ELEVATUS
ARCHITECTURE

A D D E N D U M

Project No.:	2601701	**Addendum No:**	01
Project:	AF26-07 Fort Wayne International Airport, General Aviation Hangar 2070	Date:	11/6/2026

ADDENDUM NO. 01, to Drawings and Specifications dated 10/21/2026, for AF26-07 Fort Wayne International Airport, General Aviation Hangar 2070 for the Fort Wayne Allen County Airport Authority; as prepared by ELEVATUS Architecture, 111 E. Wayne Street, Suite 555, Fort Wayne, IN 46802

Site Utility Plan

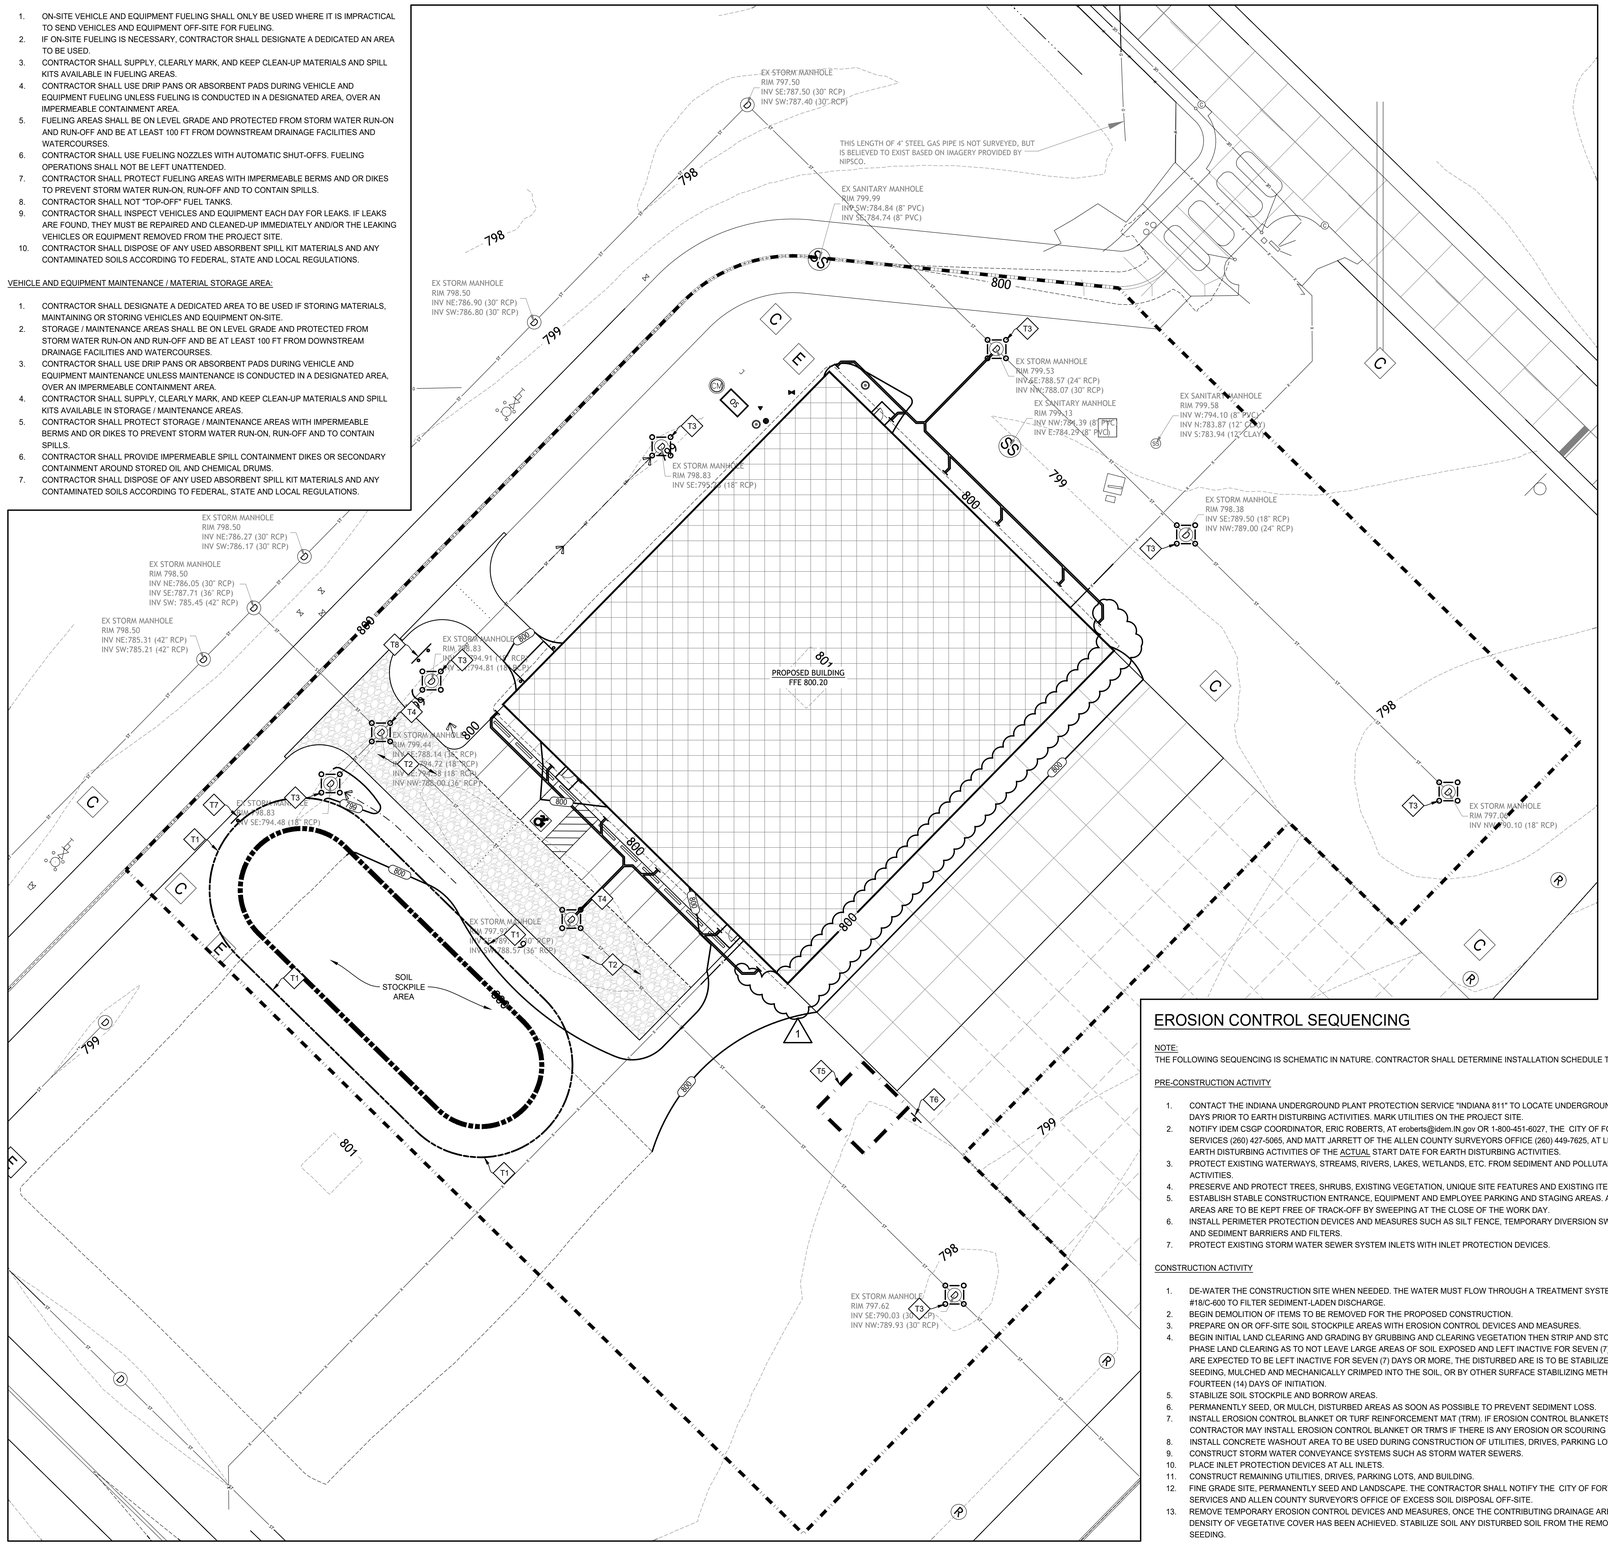
ITEM NO. 3.02 - DRAWING NO. C-400 Site Utility Plan

2 Plan East Elevation
1/8" = 1'-0"

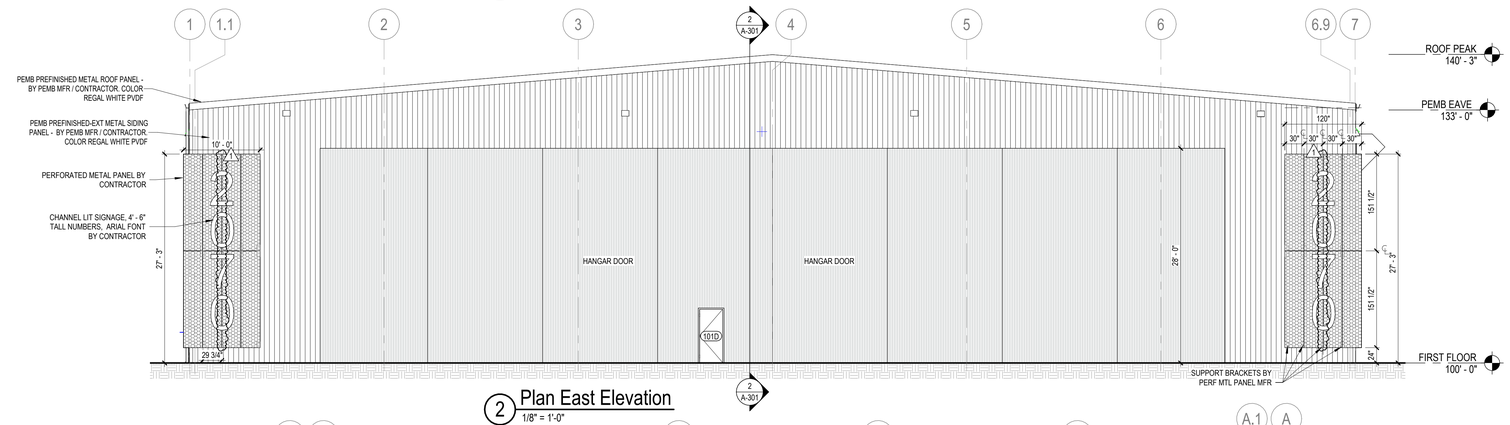
ITEM NO. 3.05 - DRAWING NO. A-201, Building Elevations

A. Revision on Plan East Elevation such that:
   1. 60” x 151 ½” perforated metal panels are split into two 30” x 151 ½” panels.
   2. Addition of eight mounting brackets, and two connecting support tubes.

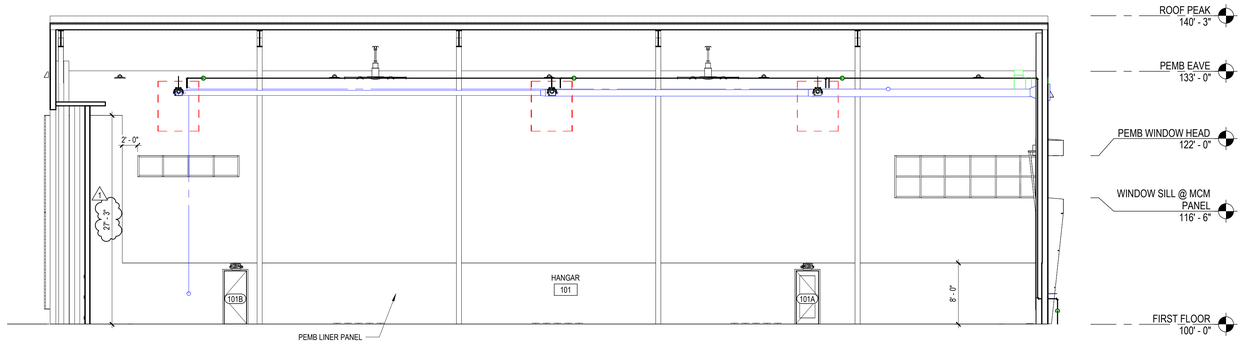
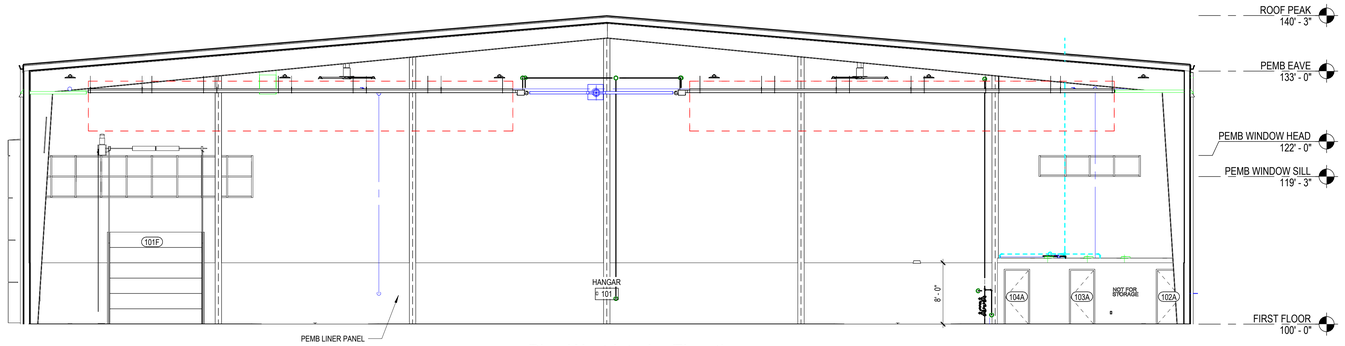
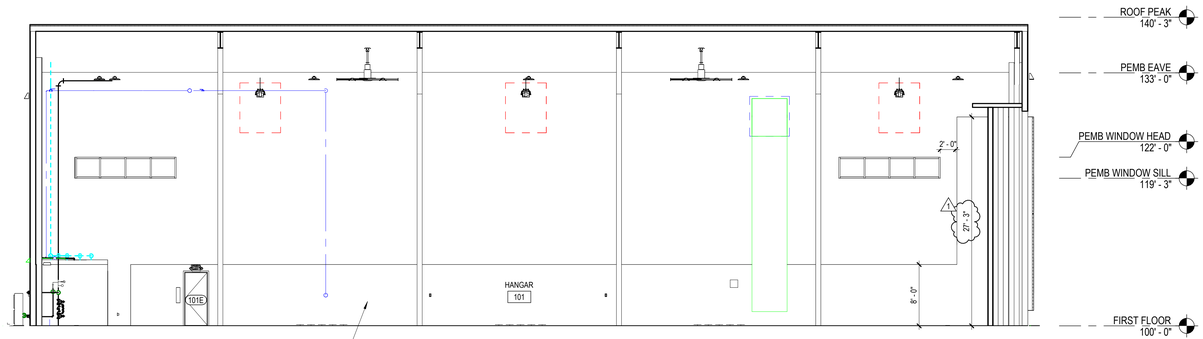
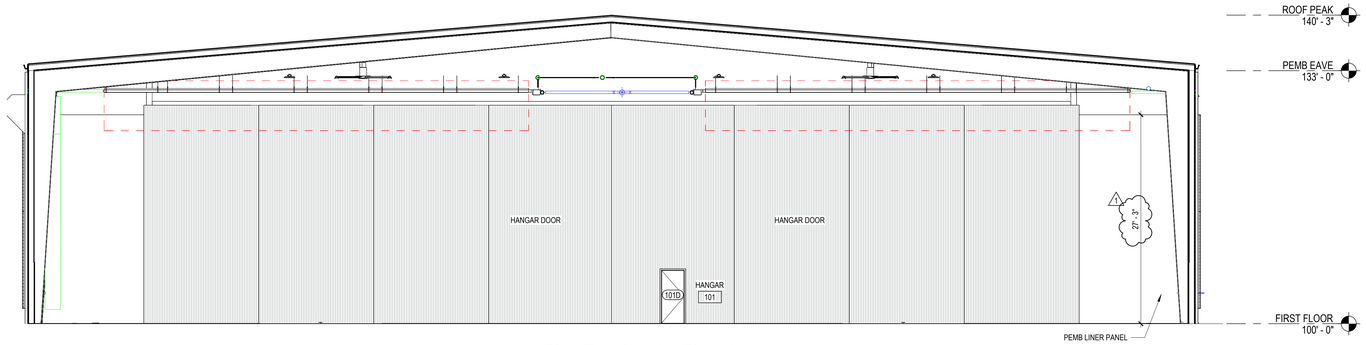
ITEM NO. 3.06 - DRAWING NO. A-211, Interior Elevations

A. Revised portion of liner panel to height of 27’-3” to conceal substructure for exterior perforated metal panels.

3 Door Soffit
3/4" = 1'-0"

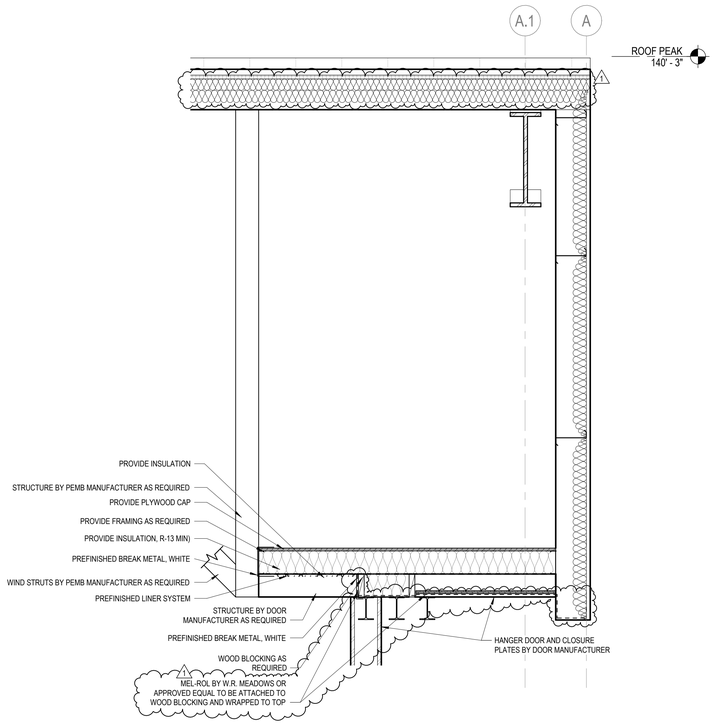
B. Revised annotation on 3/A-301, “VAPOR BARRIER ATTACHED TO WOOD BLOCKING AND WRAPPED TO TOP” to read as follows:
   1. “MEL-ROL BY W.R. MEADOWS OR APPROVED EQUAL TO BE ATTACHED TO WOOD BLOCKING AND WRAPPED TO TOP”

Building Sections and Details

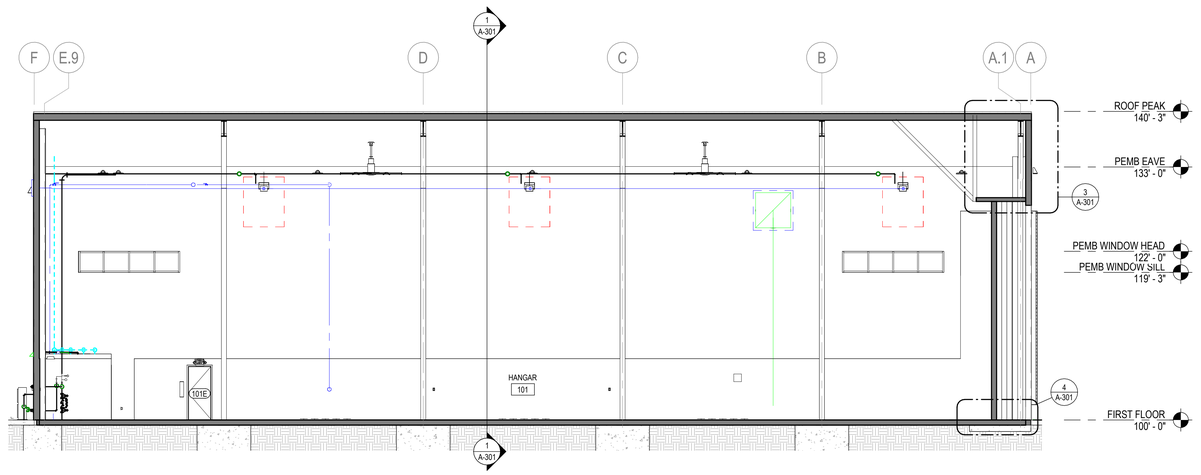
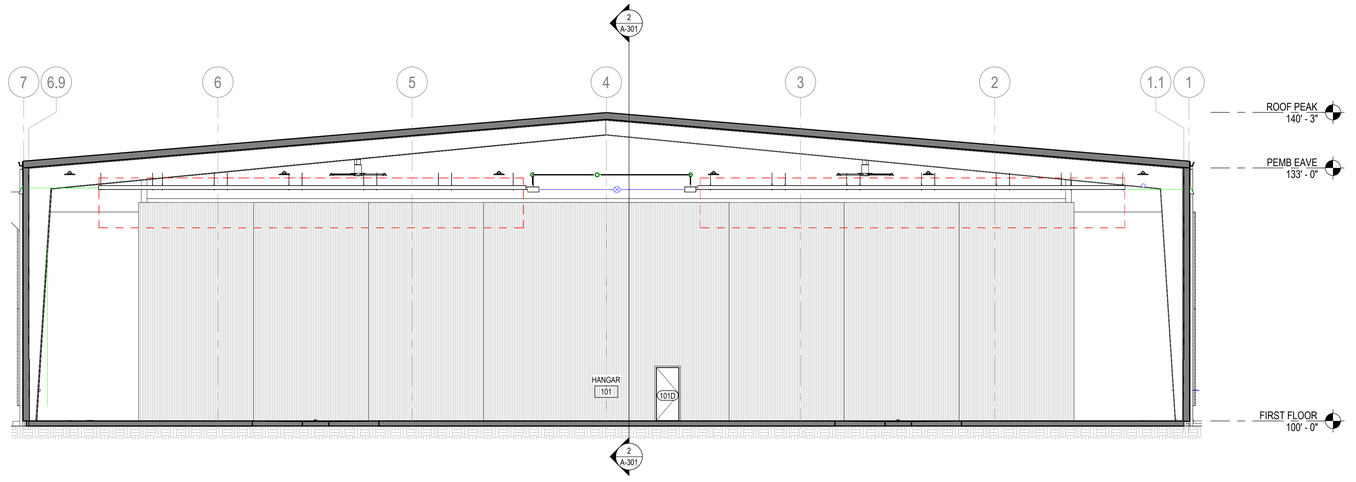
ITEM NO. 3.07 - DRAWING NO. A-301, Building Sections and Details

A. Revised visual representation of roof insulation.

C. Revised visual representation of roof insulation.

Wall Sections and Details

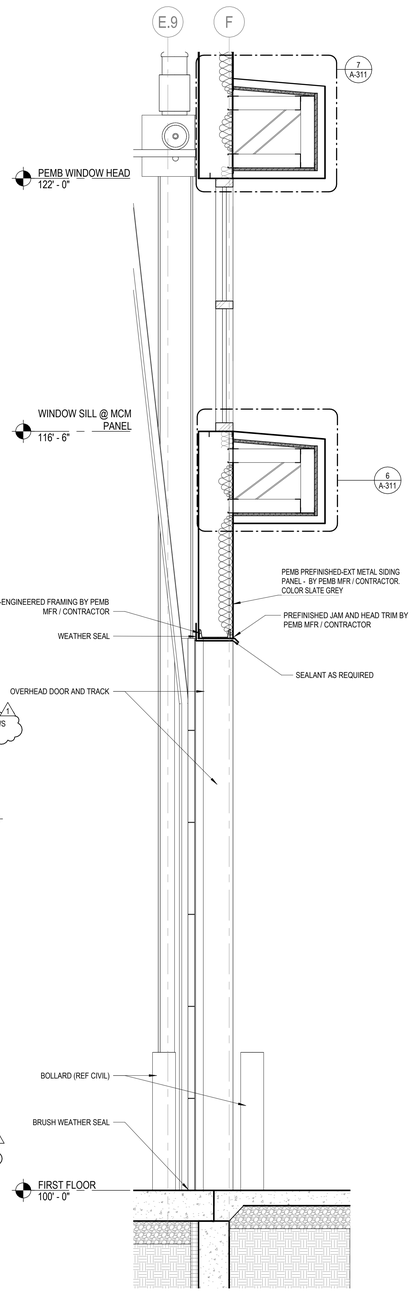
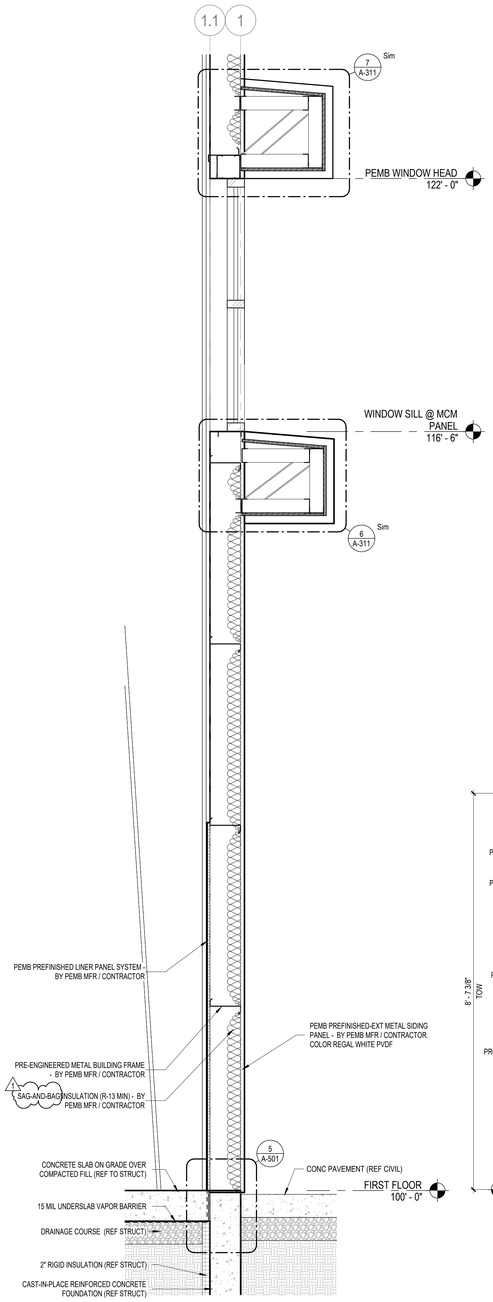
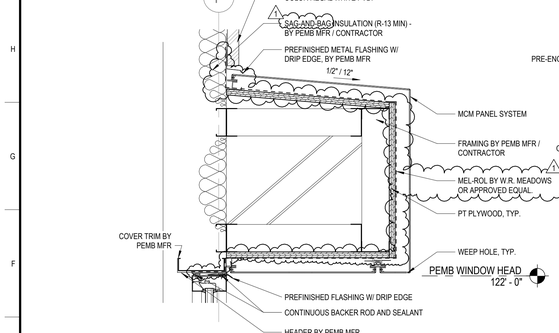
ITEM NO. 3.08 - DRAWING NO. A-311, Wall Sections and Details

A. Revised all “VINYL-FACED INSULATION (R-13 MIN) – BY PEMB MFR / CONTRACTOR” annotations to read as follows:
   1. “SAG-AND-BAG INSULATION (R-13 MIN) – BY PEMB MFR / CONTRACTOR”
